22-ZONE-0012 & 22-ZONE-0076

This development  
is not compatible.

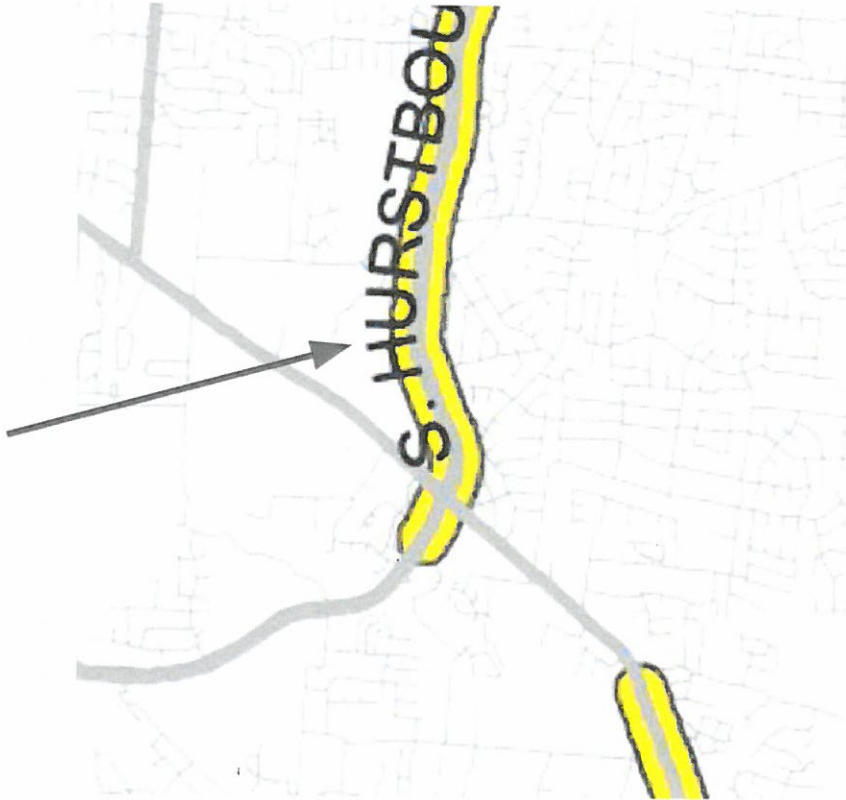
- The proposed uphill development has 3-story buildings with walkouts and balconies towering over rural single-family homes, directly looking at our most private spaces.
- This is the projected view from backyard of 4707 Walnut Hills Dr vs the current view.
- Why can't these buildings be turned perpendicular with a larger setback to preserve privacy and not block natural light?

- This is the projected view from the backyard of 4805 Walnut Hills Dr vs current view.
- These buildings are too tall to be that close to a downhill 0.63 density neighborhood.
- Shorter buildings turned perpendicular with a larger setback would be more appropriate.

- The proposed uphill development is directing car lights and pollution directly toward single family homes.
- The abutting neighborhood is rural with homes on septic tanks, well water, and propane heat.
- This is the projected view from backyard of 4905 Walnut Hills Dr vs current view.
- A continuous berm, fence, and tree combo along the entire perimeter would assist the transition.

## Core Graphic 9

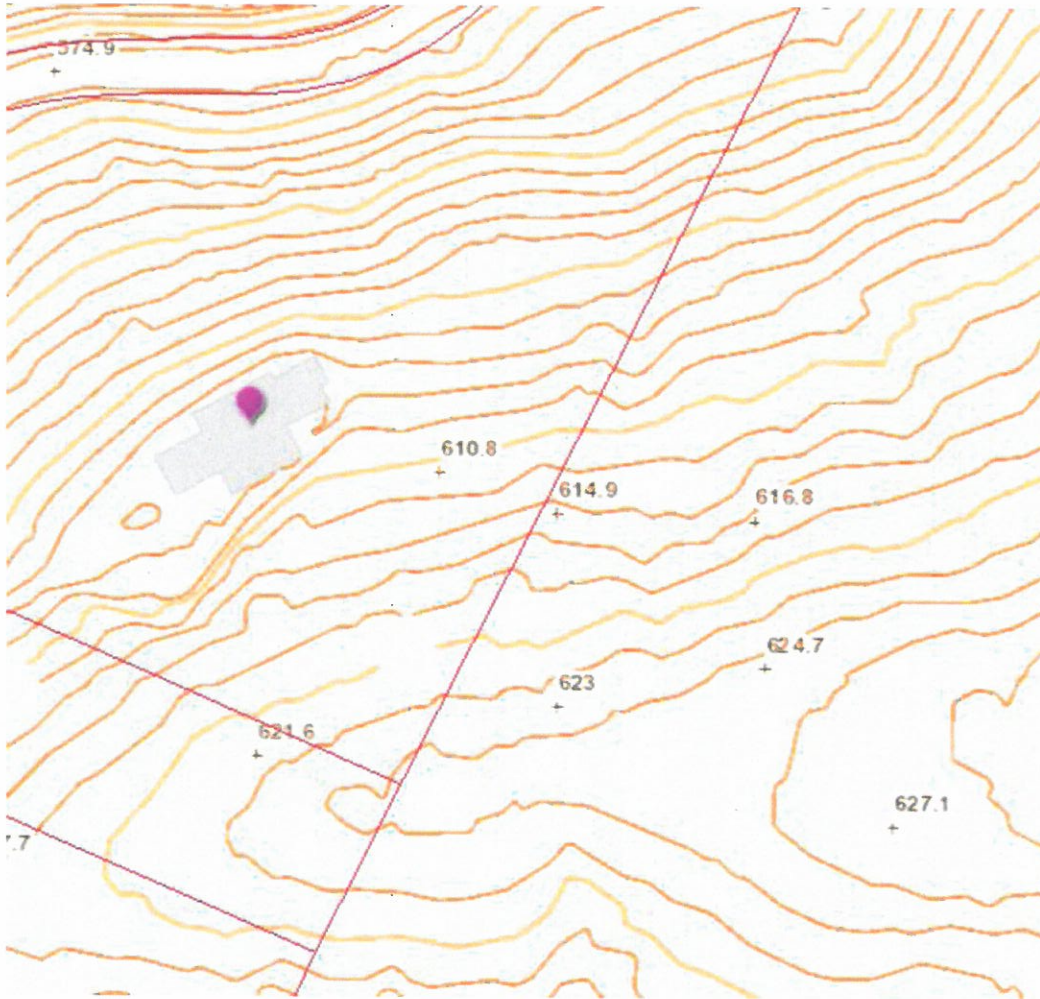
- Adding ~1,200 vehicles, more sitting traffic, and removing all of the trees will make this even worse.
- By adding more tree coverage along the perimeter, we can help improve the air quality and reduce health problems from carbon monoxide exposure.
- This will also assist in the restoration of all of the mature trees that will be destroyed by the developer.

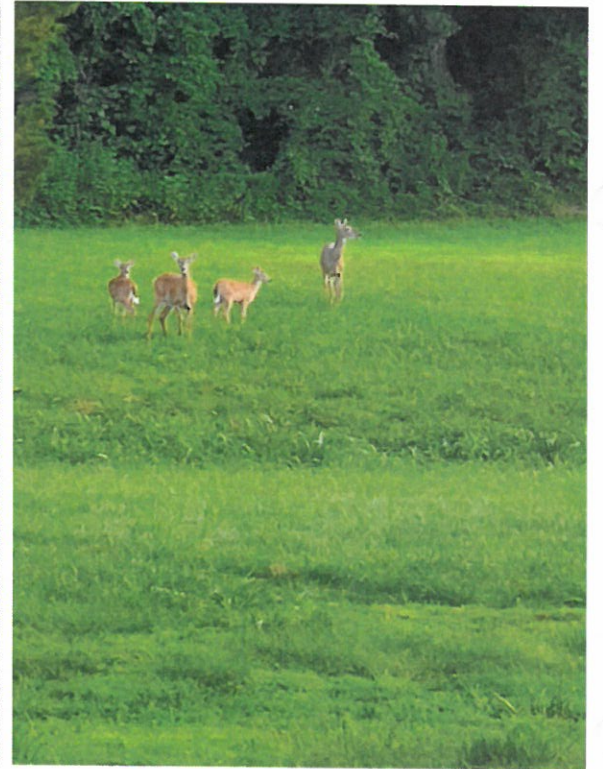
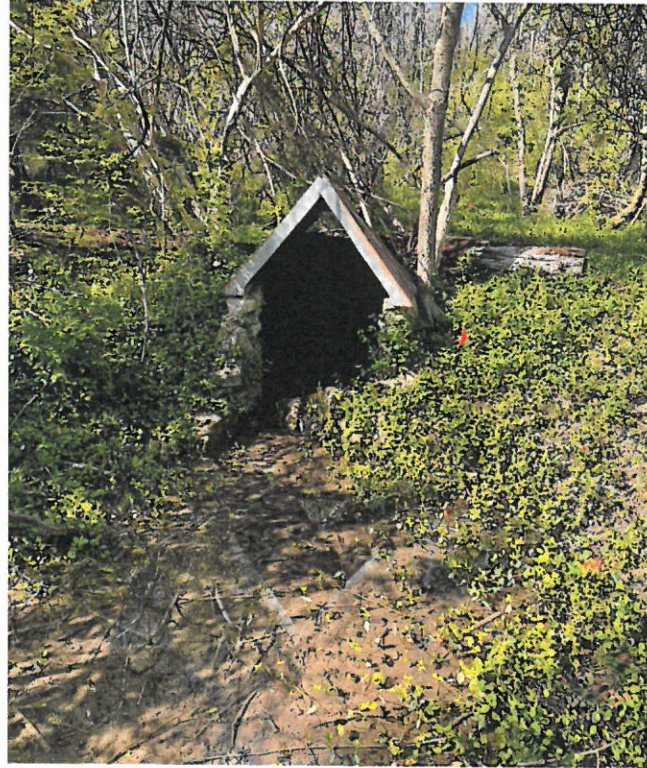
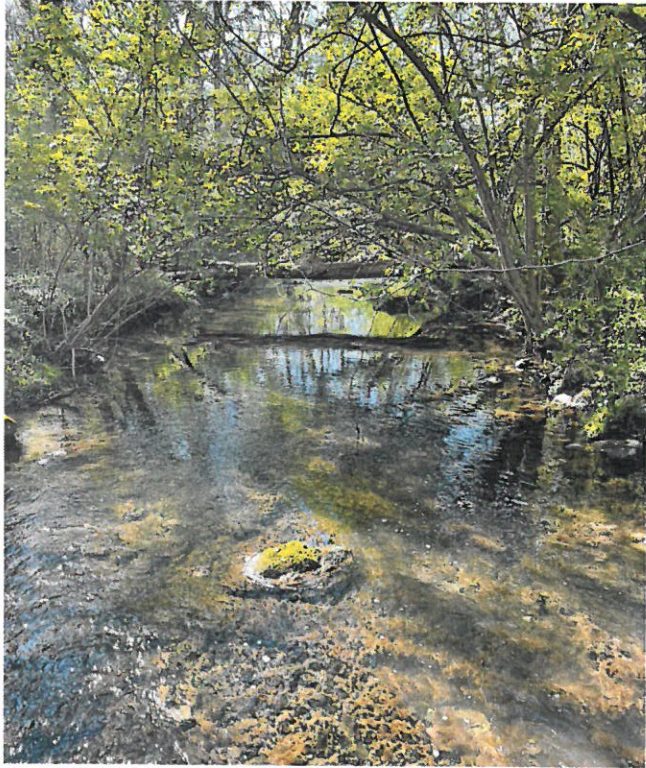
- This basic design is more suited for a military base and not the Scenic Parkway of Hurstbourne Parkway and overlooking Fern Creek.
- This development lacks MIXED USE and aesthetically doesn't fit in with the area.

Smaller 2-story buildings placed in different directions with an abundance of landscaping, trees, large buffer zone, privacy fence, berm, and green space. The building materials use a mix of brick and vinyl.

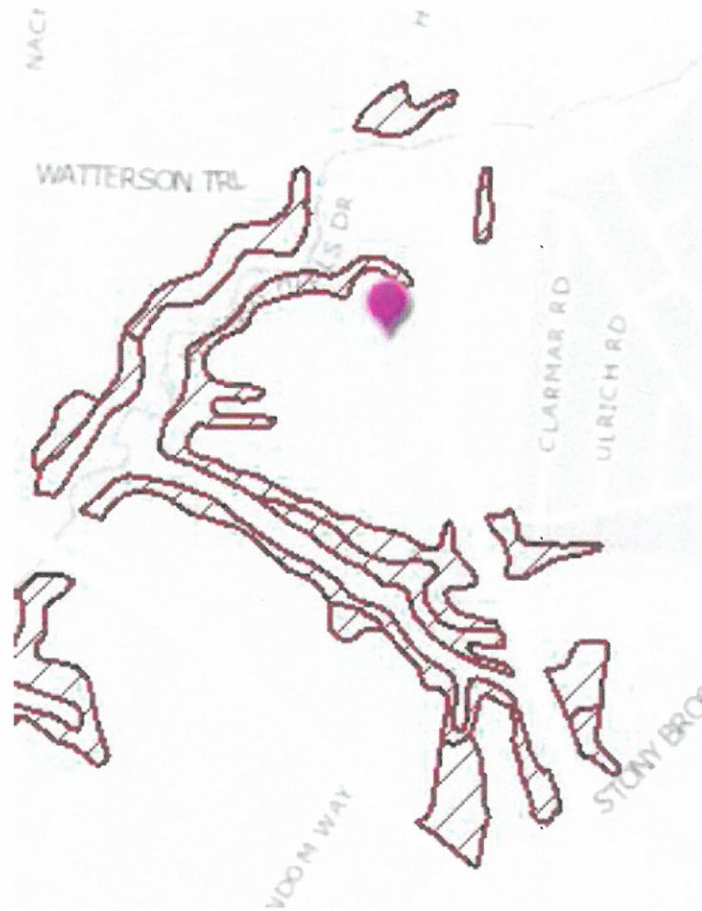
- According to Lojic online and the Geotechnical Report, the proposed development is sitting on karst terrain, including clays with shrink/swell potential.

- The proposed development will be built on several sinkholes. This will modify the natural flow of water.
- In reviewing the karst study, section 4.2.1.2 states that: *“Engineering works and site development can result in acceleration of incipient sinkhole development or encourage new sinkhole formation. These features may appear dormant in their existing state, but subsidence can be activated by changes in the natural drainage pattern due to construction works.”*

- The new and increased runoff and pollution downhill residents will take on is exponential.
- The health of the creek is severely impaired and MSD has already overloaded this waterway.

- This development discourages the natural features of the terrain and requires the destruction of the pond, wetlands, and the waterfall, and adversely impacts the stream at the West corner by relocating the natural drainage beginning at Hurstbourne Pkwy, and adversely impacts the single-family homes located on steep slopes surrounding the development.

4700 S Hurstbourne Pkwy underground stream exiting at cliff 4819 Walnut Hills Dr (left), approximate location of sinkholes according to developer's plans, and the approximate location of sinkholes on abutting properties (right).

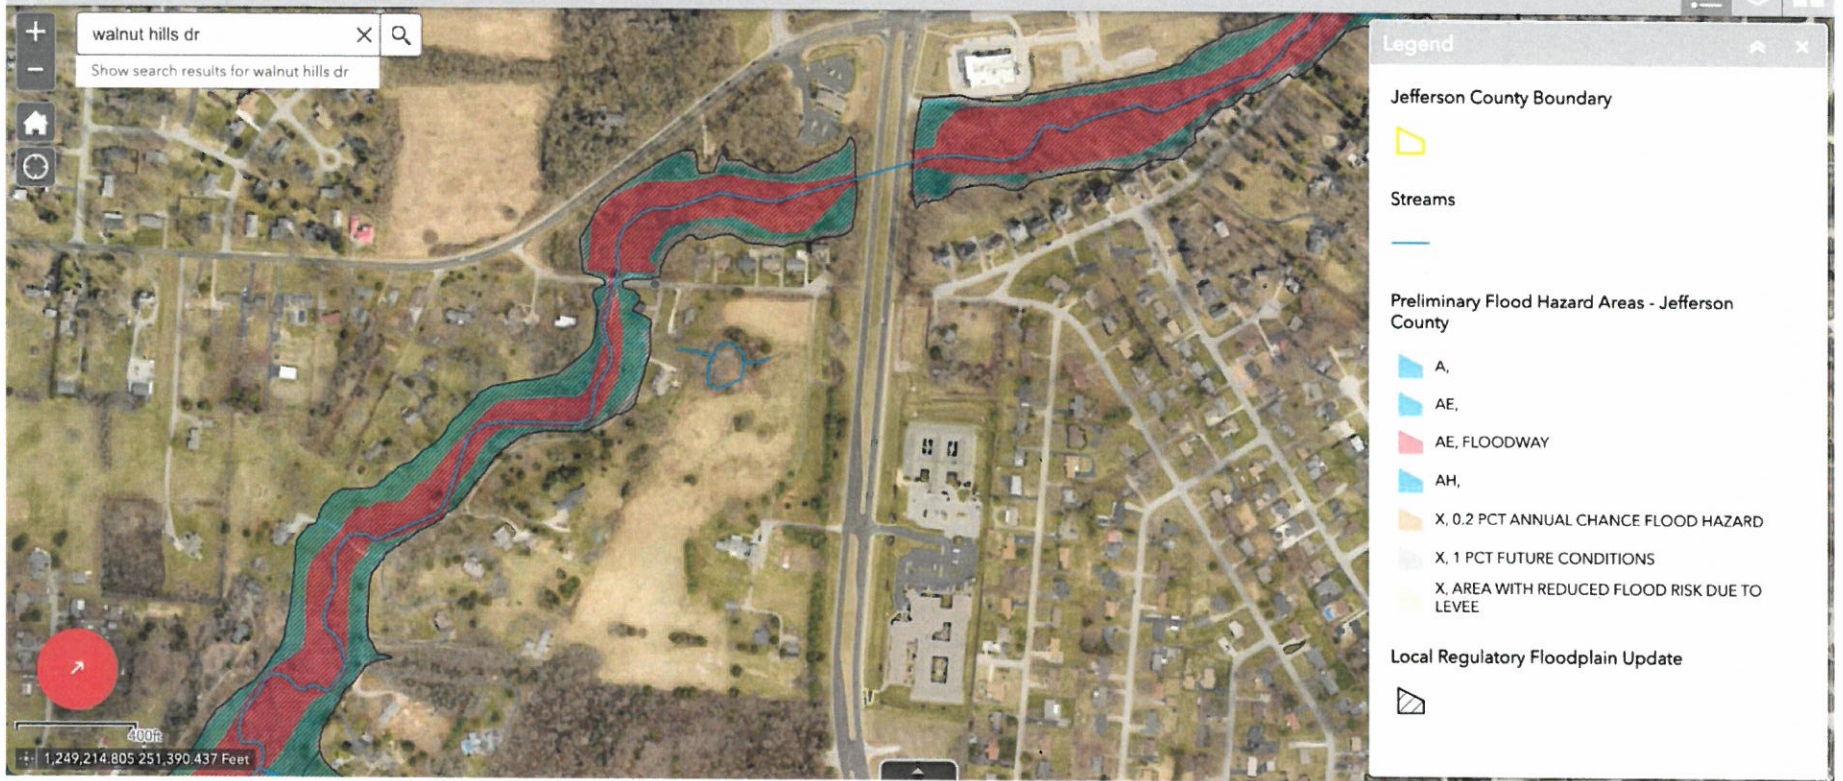
According to Lojic Online, the property is nearly surrounded by steep slopes, unlike any other development on Hurstbourne.

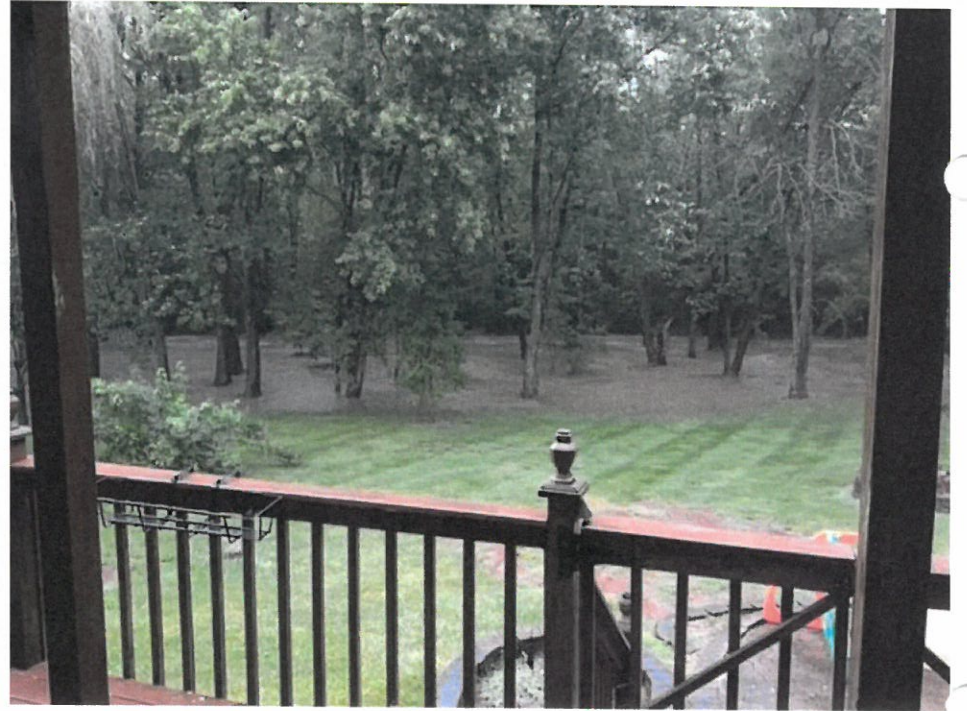
Fern Creek is a FEMA Regulatory floodway. Due to Fern Creek being a FEMA Regulatory Floodway, surrounding properties are to be further regulated (according to FEMA).
